**FINAL DRAINAGE REPORT
FOR
LATIGO TRAILS FILING NO. 9
AND
ADDENDUM TO MASTER DEVELOPMENT/
PRELIMINARY DRAINAGE PLAN
FOR LATIGO TRAILS,
EL PASO COUNTY, COLORADO**

September 2021

Add "PCD File No. SF-21-037"

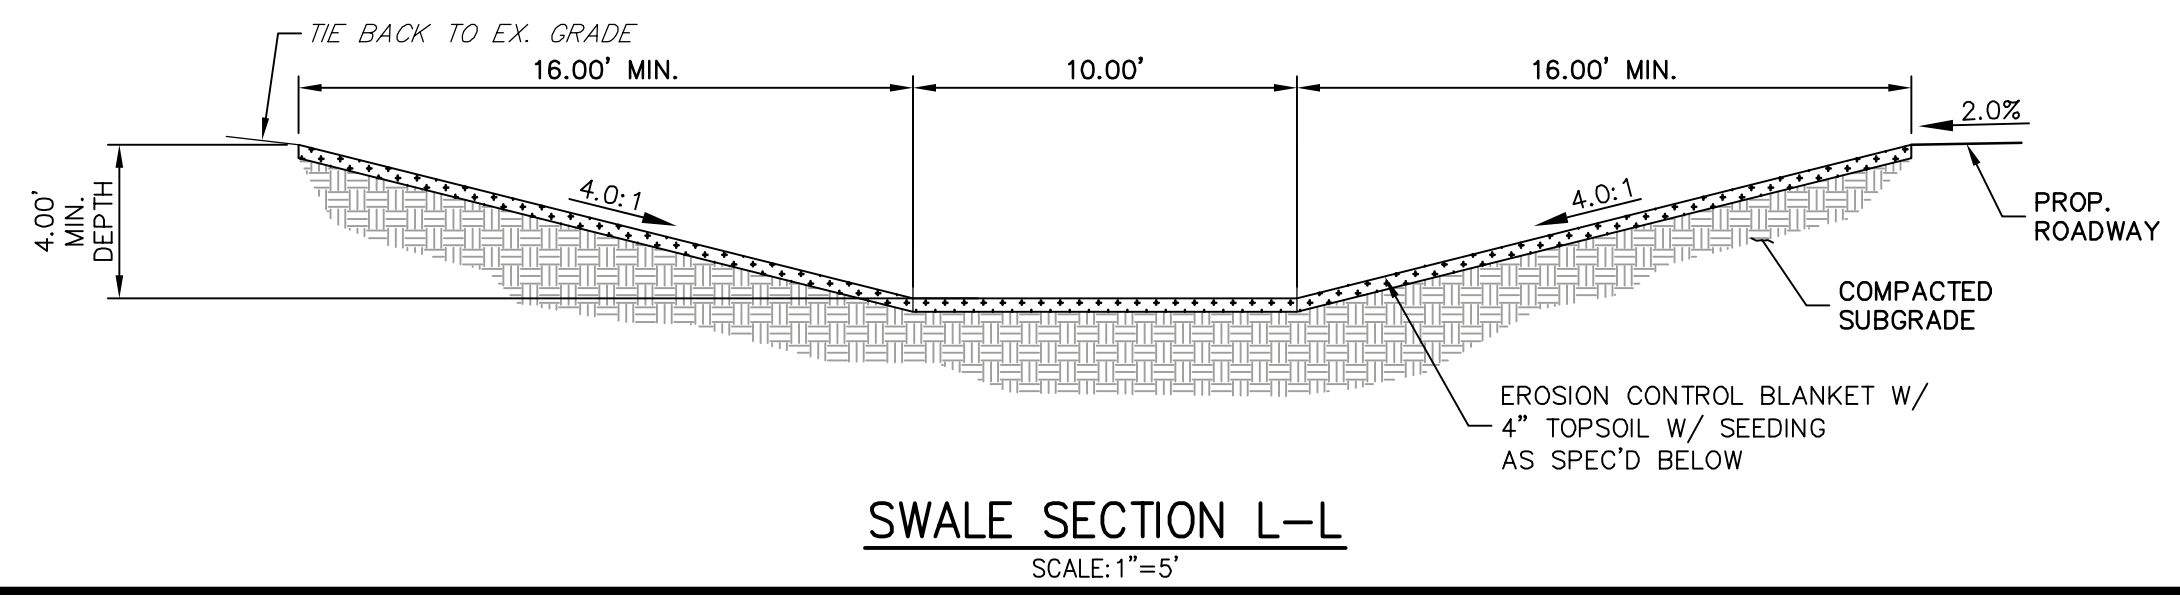
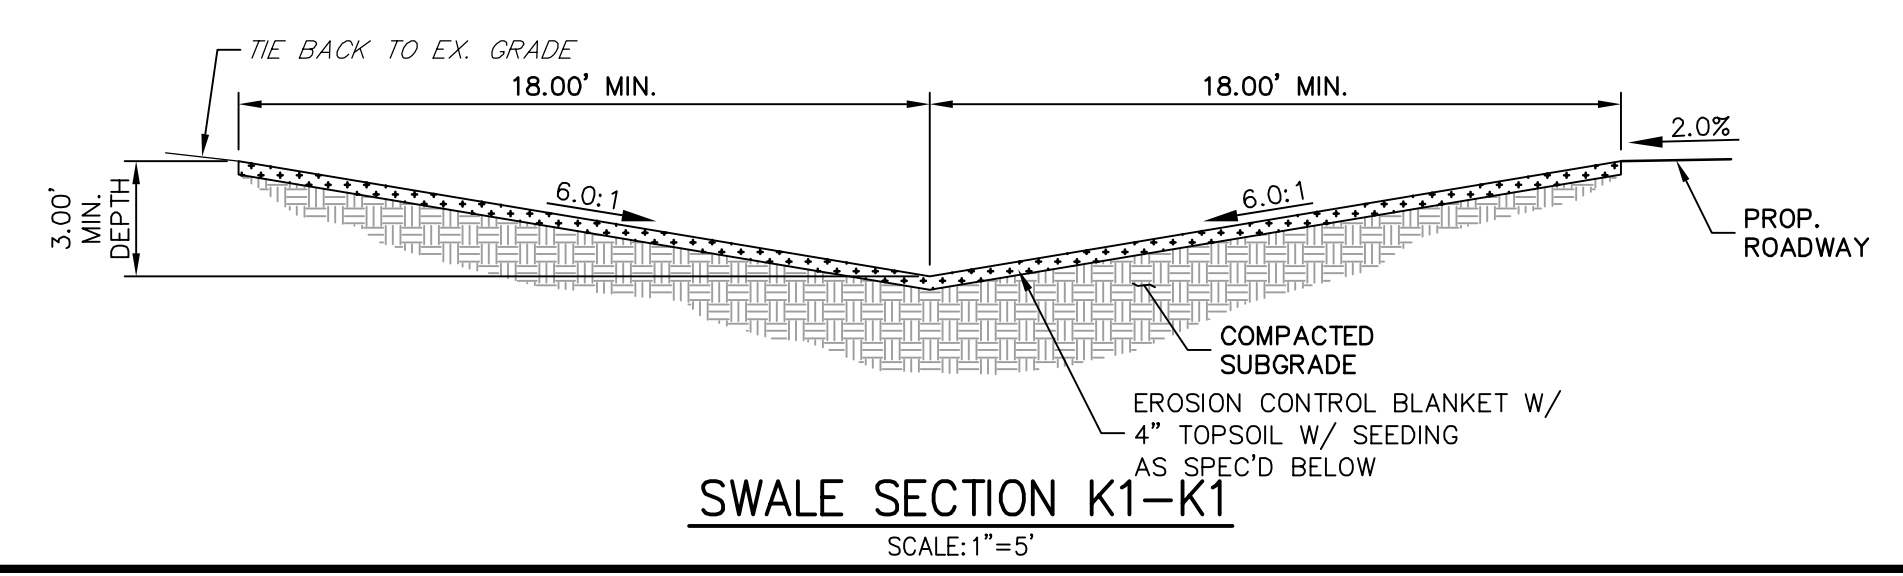
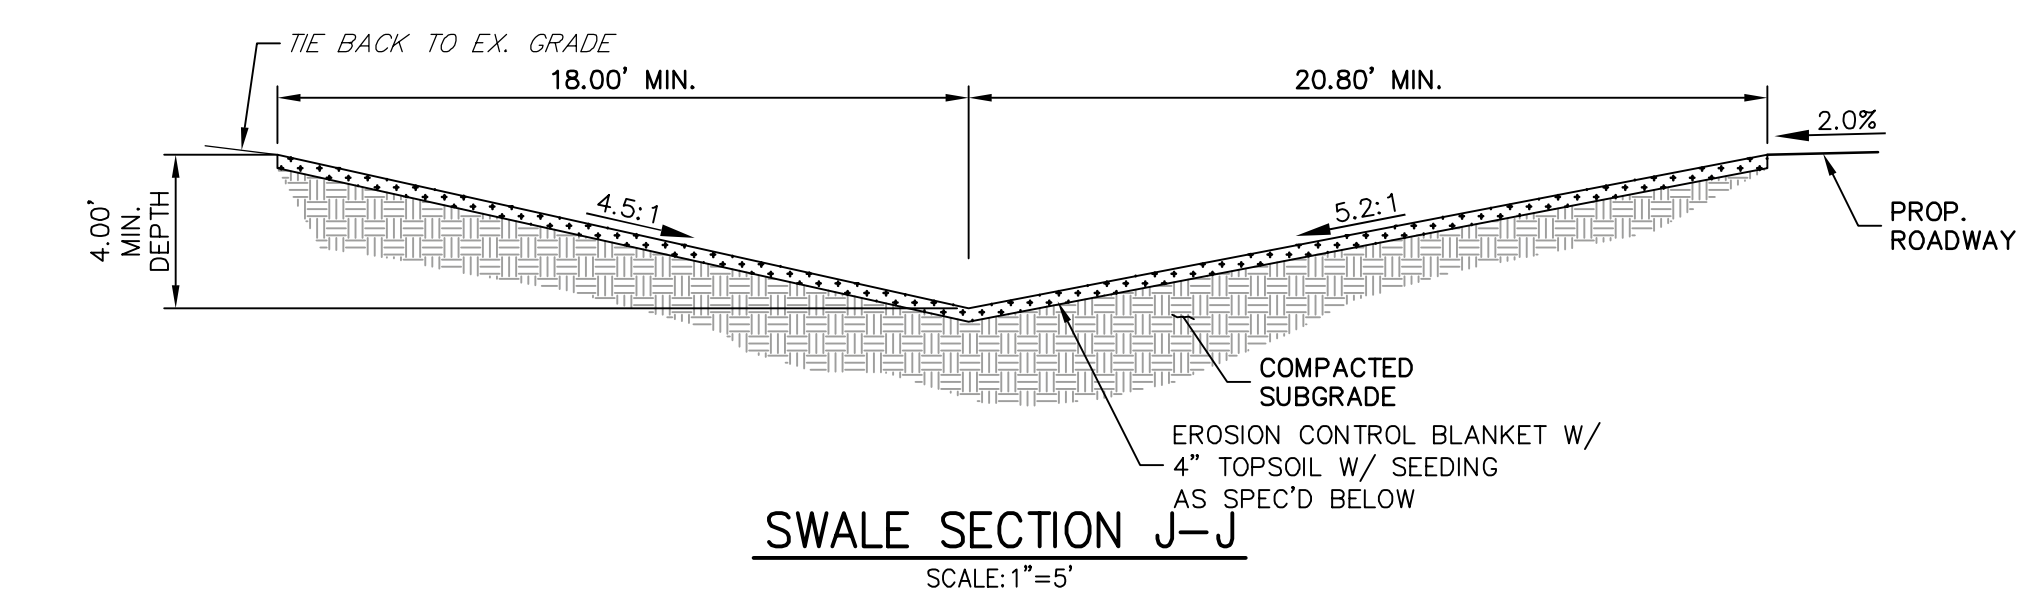
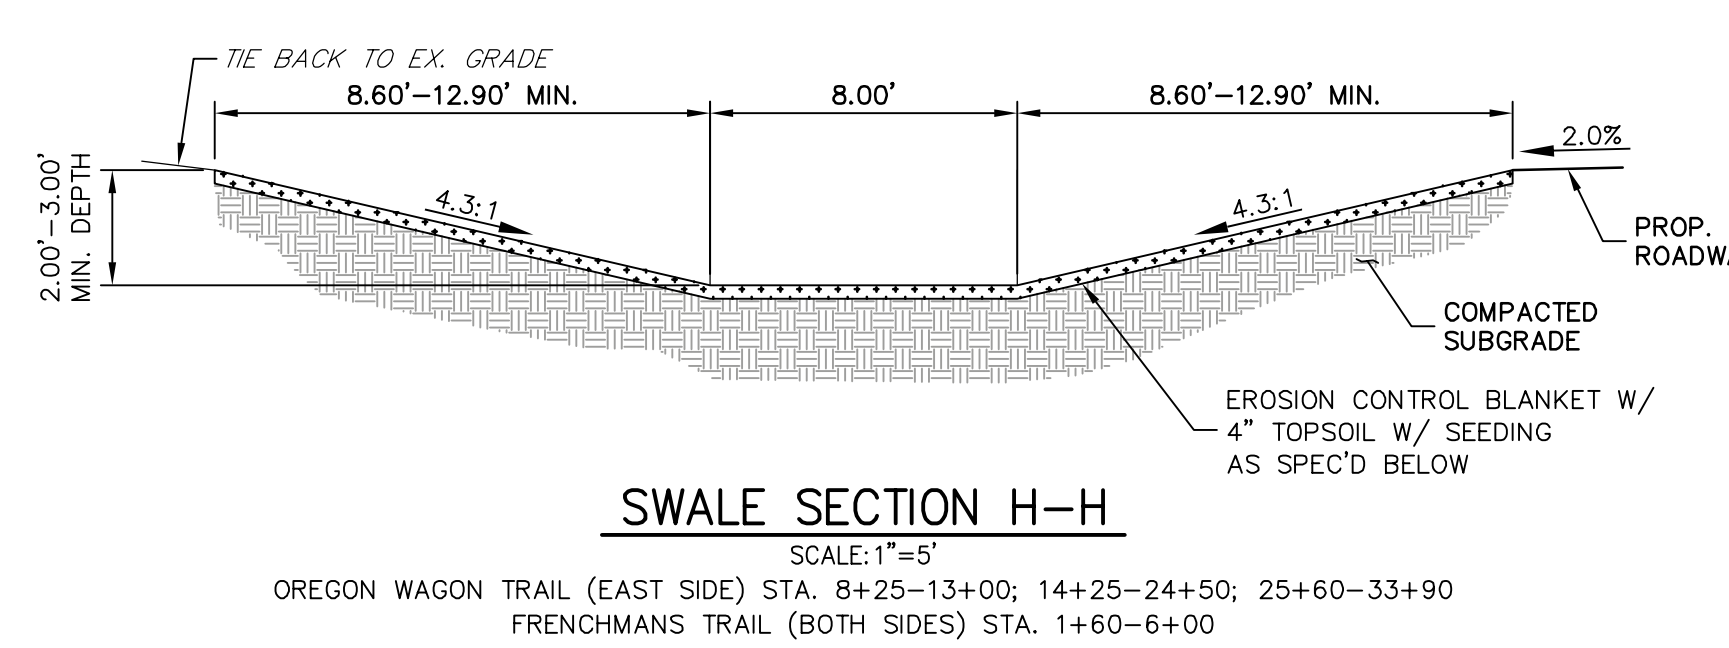
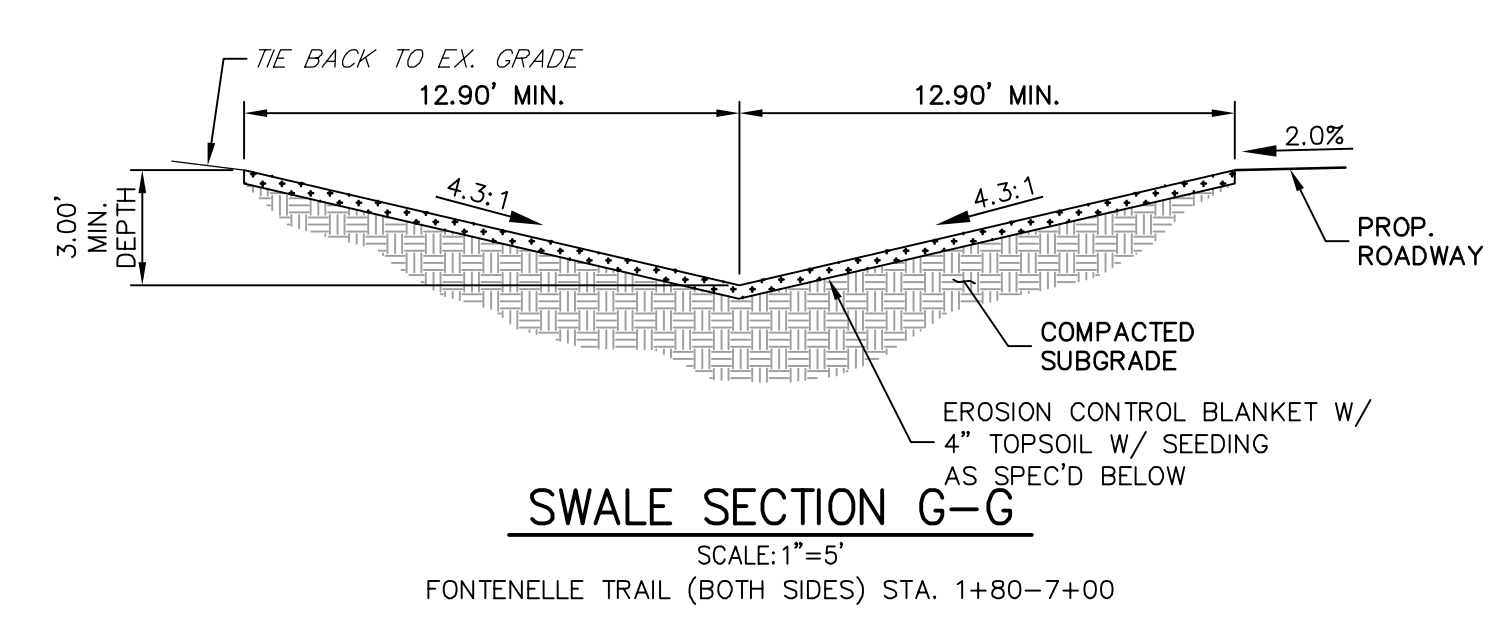
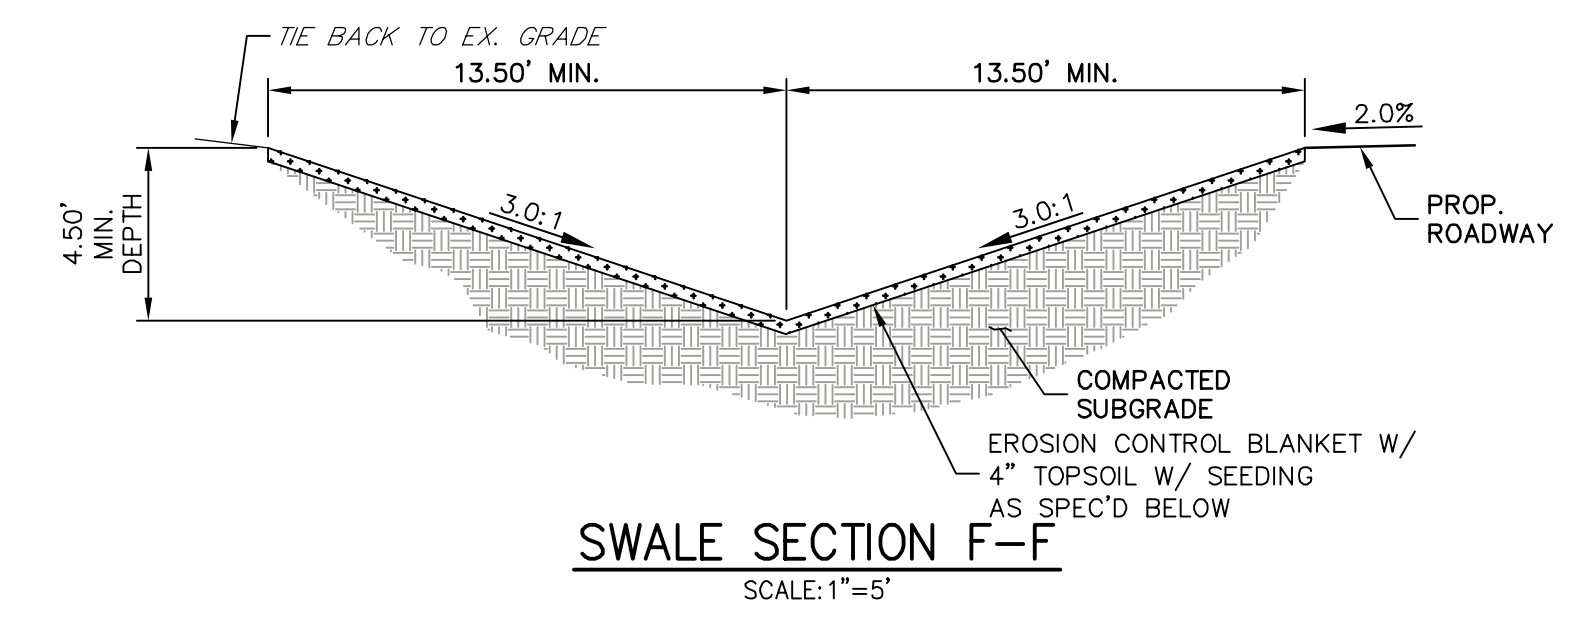
Update the cross sections to identify the specific ECB product proposed and include the product specification in the drainage report that shows the permissible velocity. At this time staff is unable to confirm if the swale velocity is less than or greater than the permissible velocity of the ECB. Review the swale velocity check relative to the ECB product will be conducted on the resubmittal.

PROPOSED CUHP/SWMM MAP
 LATIGO TRAILS ULTIMATE CONDITION
 JOB NO. 25175.01
 9/14/2021
 SHEET 1 OF 1

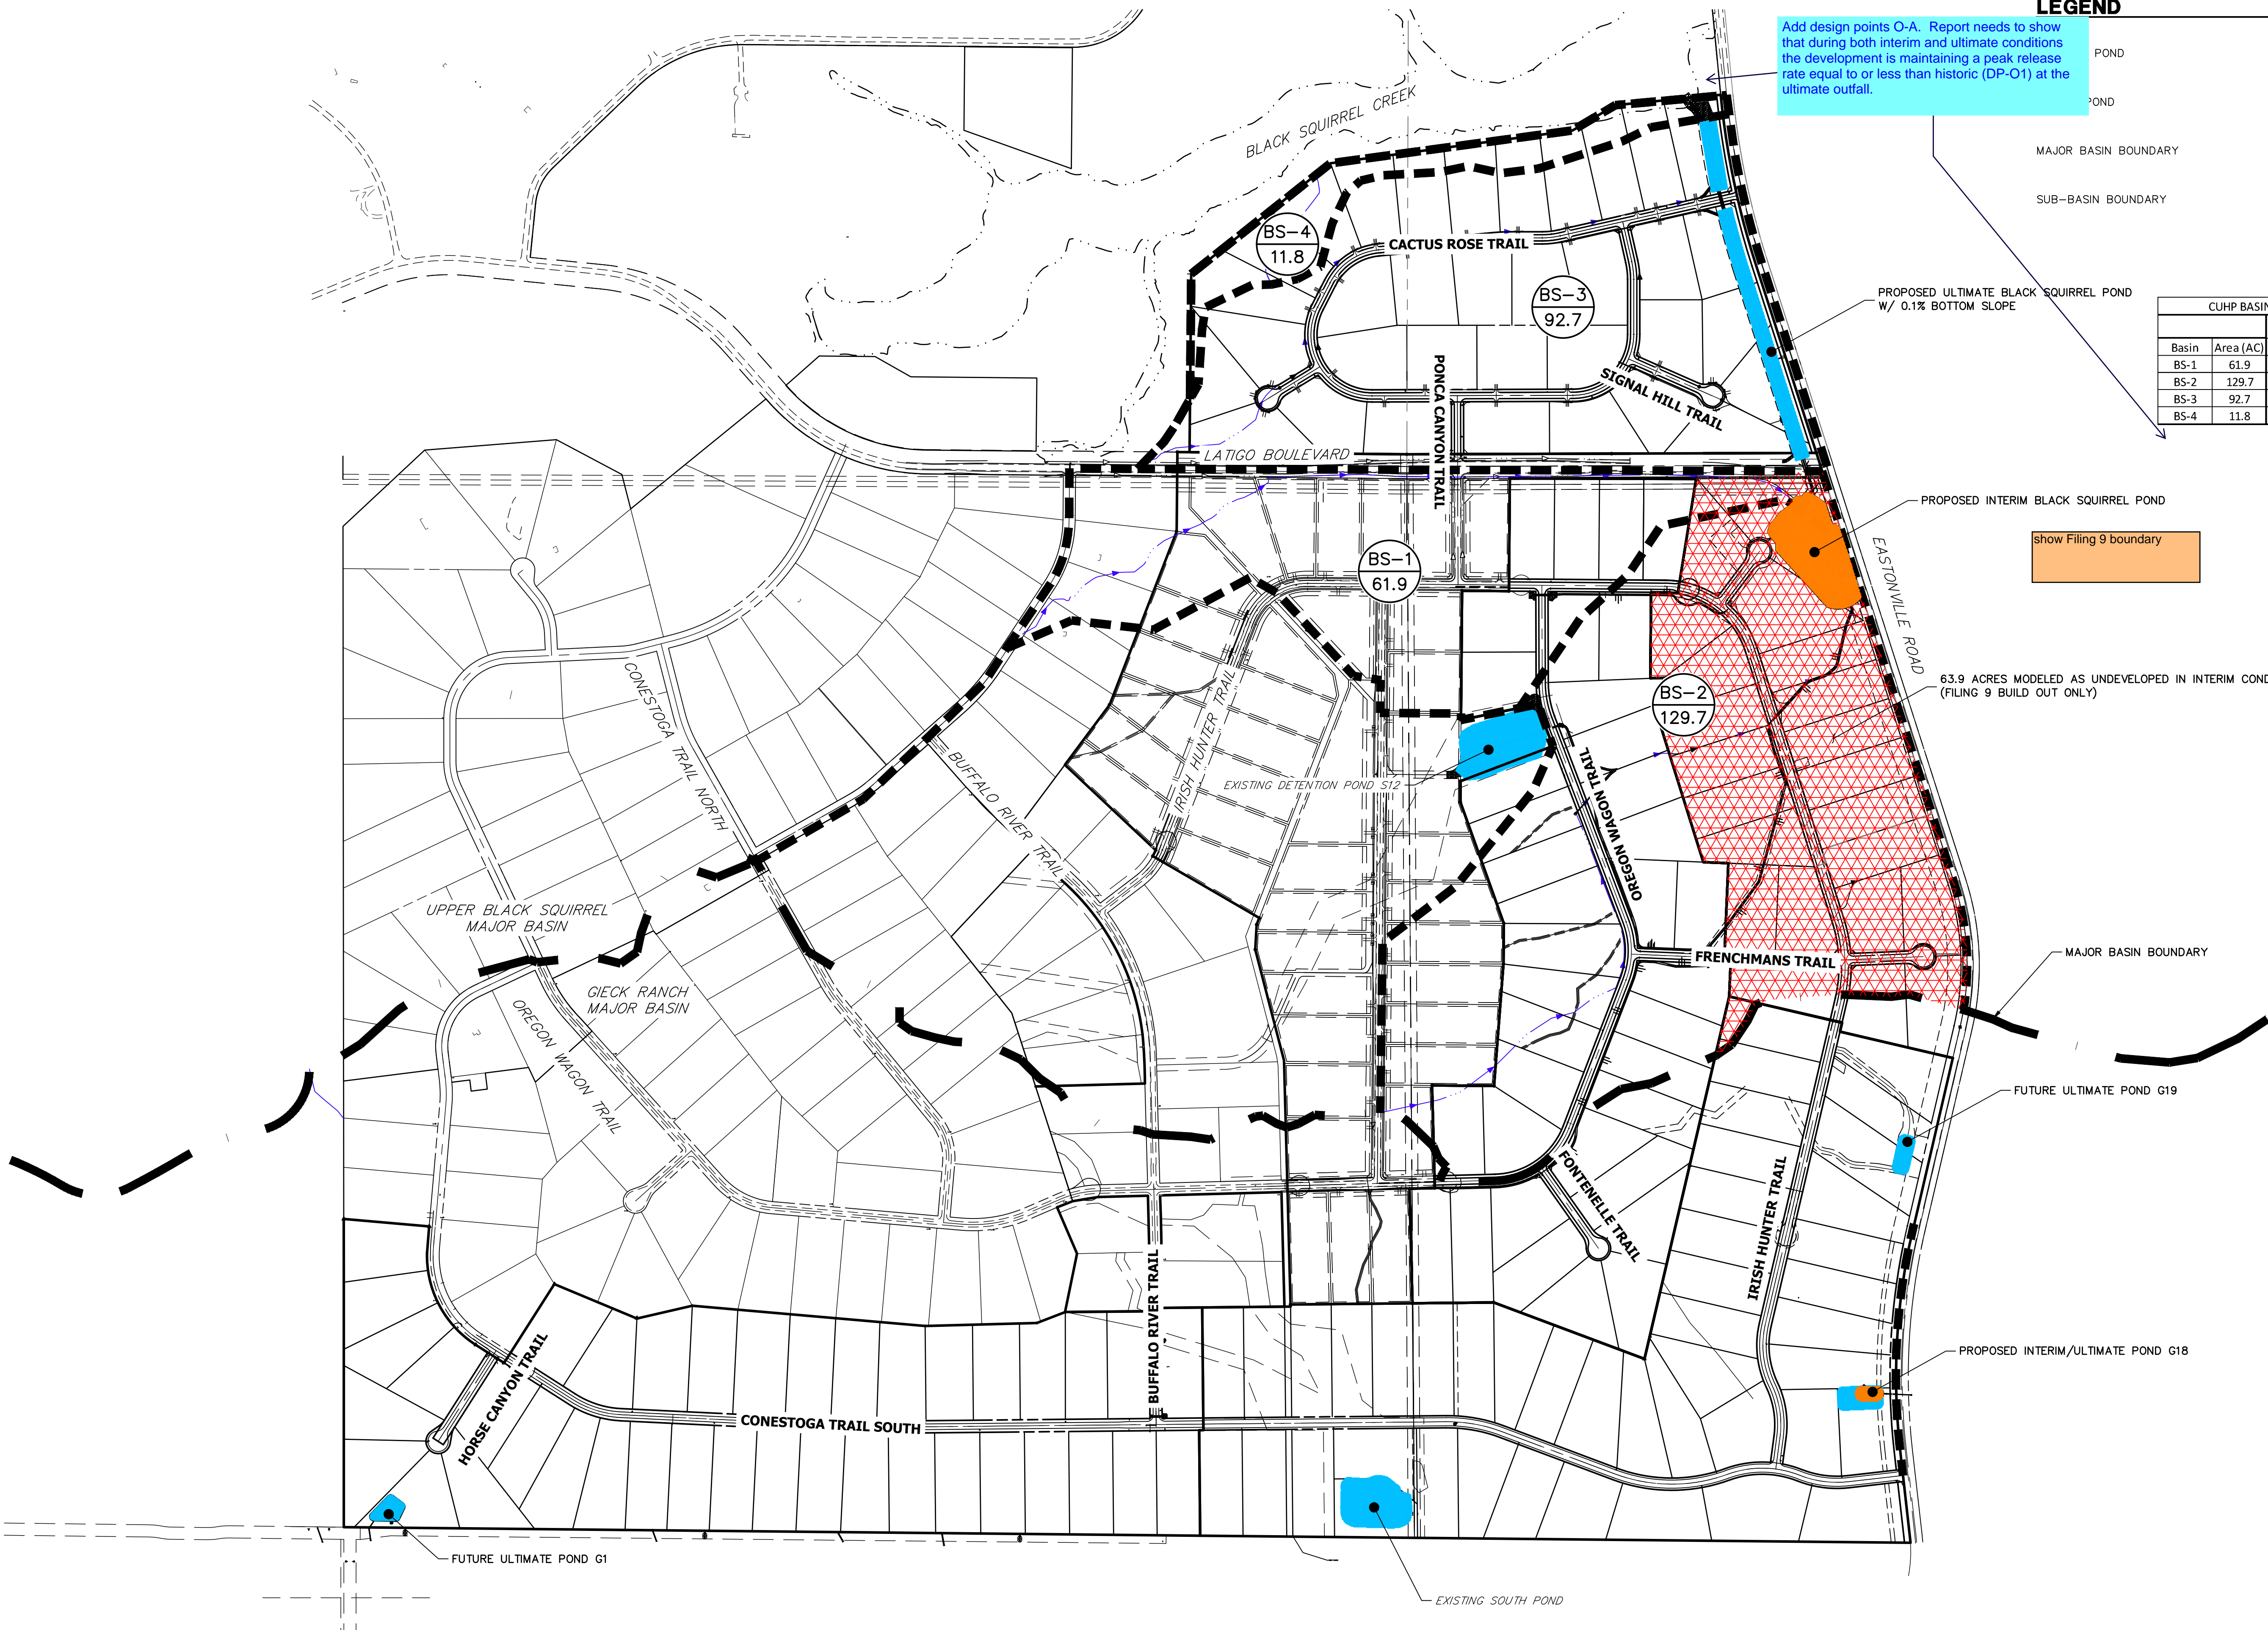
Add design points O-A. Report needs to show that during both interim and ultimate conditions the development is maintaining a peak release rate equal to or less than historic (DP-O1) at the ultimate outfall.

Add a pond summary table:
 - Storage (ac-ft)
 - Qin
 - Qout
 - release time.
 Report needs to show time to drain is in conformance with SB 15-212

show Filing 9 boundary
